RE: Submission on Draft Planning Controls for UTS Key Site, Pyrmont Peninsula

UTS INDIGENOUS RESIDENTIAL COLLEGE,
DPIE Review

Draft Pyrmont Peninsula Sub-Precinct Master Plans and Draft Planning Controls Response Report, Design 5 – Architects Pty Ltd 4th February 2022

Figure 15 – DPIE 'Tower' building envelope (Option 1)
(Design Guidelines, 2021 (Hassell))

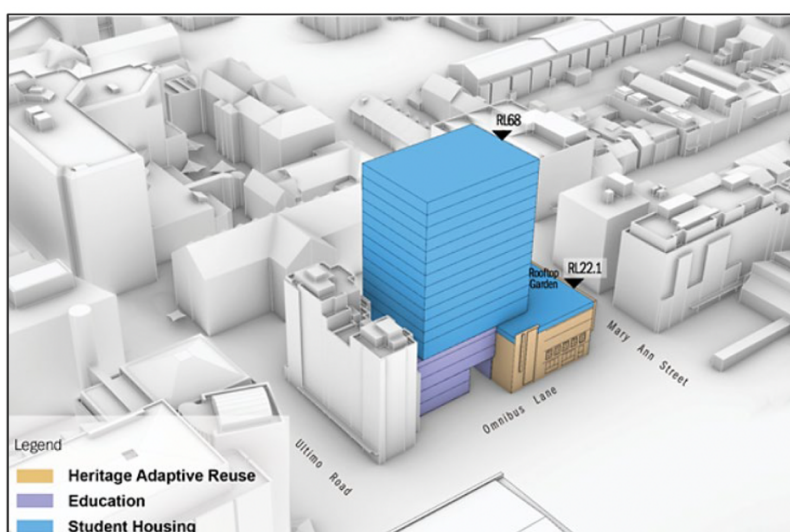
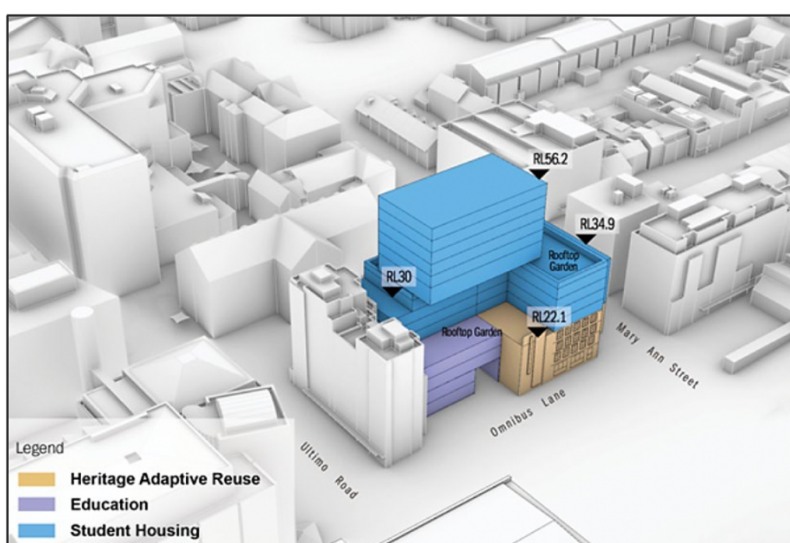
The comment in the DPIE report relating to the CMP, *“The report found historical information relating to earlier designs of the NCR building, which suggested that the building was originally expected to be eight storeys, rather than the four it is currently built to,”* is misleading as no documentation for an eight-storey building has been found during the research conducted by Design 5 while preparing the CMP. This information is from an article that was written by a journalist in a building magazine and possibly in the context of demonstrating the flexibility of the design. No primary source for this eight-storey reference has been found. None of the documentation found in Design 5’s research suggests it was to be an eight-storey structure. Original plans indicate that the building was originally designed as a three-storey structure, later built with one additional floor.

The bulky massing and form of the envelope does not have the nuanced approach to the context evident in the reference design proposed by UTS. In any envelope guideline for a site there is a potential for a proponent to completely fill the agreed envelope and still comply with the planning controls. In this instance such an outcome from the Option 1 envelope in the DPIE document would be overbearing on both the NCR Building and its neighbours. In this option, there is limited scope to make a positive contribution to the public domain as the open space fronting Omnibus Lane will not have the desired access to natural light, particularly sunlight and will not have the flexibility offered by the ‘Precinct Heart’ in the reference design by UTS.
